U.S. Application No. 09/933,198

Docket No. 1190-0508P

AMENDMENTS TO THE DRAWINGS

FIG. 8

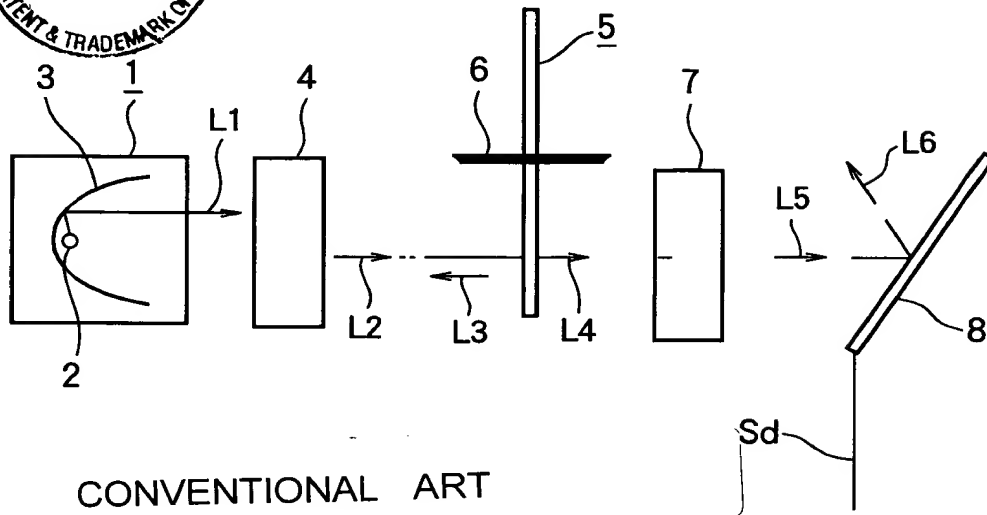
Attached hereto are three (3) annotated sheets of proposed drawing corrections for Figures 8-13, and corresponding three (3) formal drawing sheets. Figures 8-13 have all been amended to include the legend "Conventional Art" to address the objection raised in the Office Action.

CONVENTIONAL ART

FIG. 9

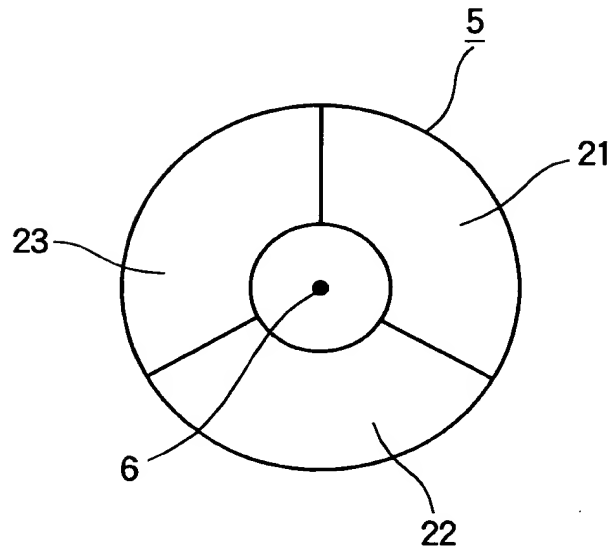
CONVENTIONAL ART

FIG.10

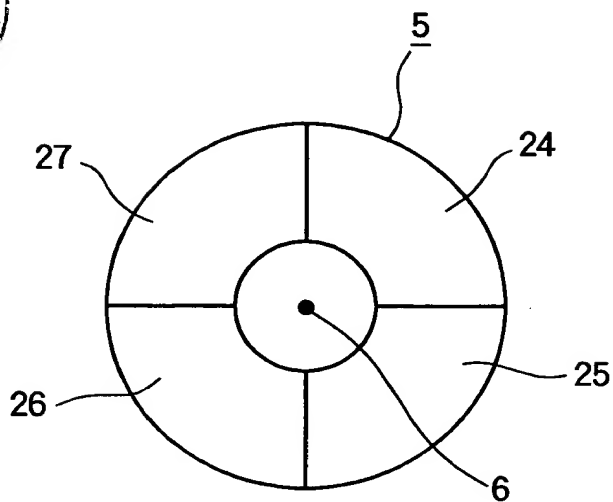
CONVENTIONAL ART

FIG.11

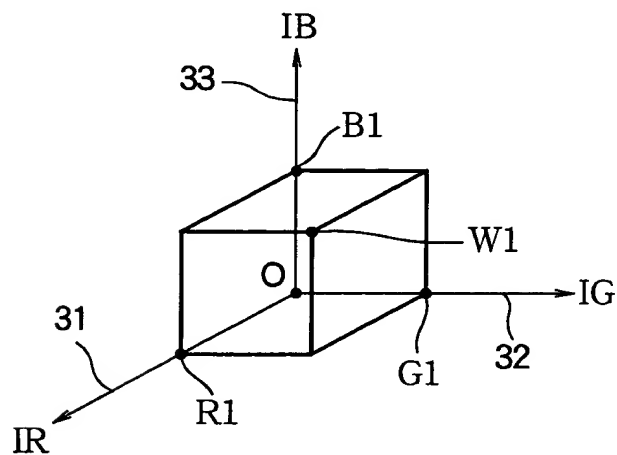
CONVENTIONAL ART

FIG.13

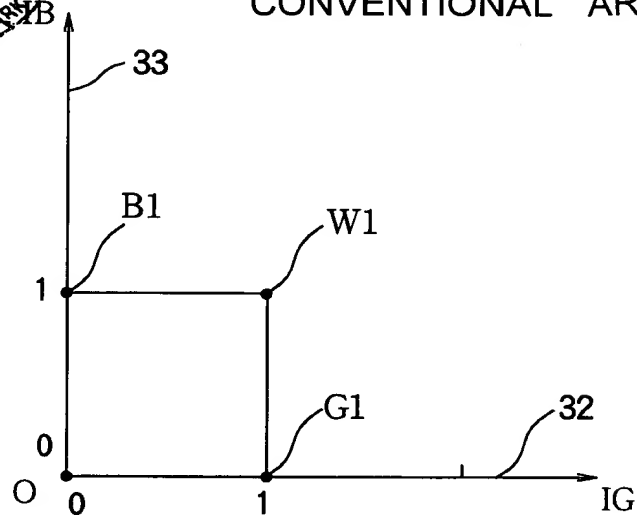
CONVENTIONAL ART
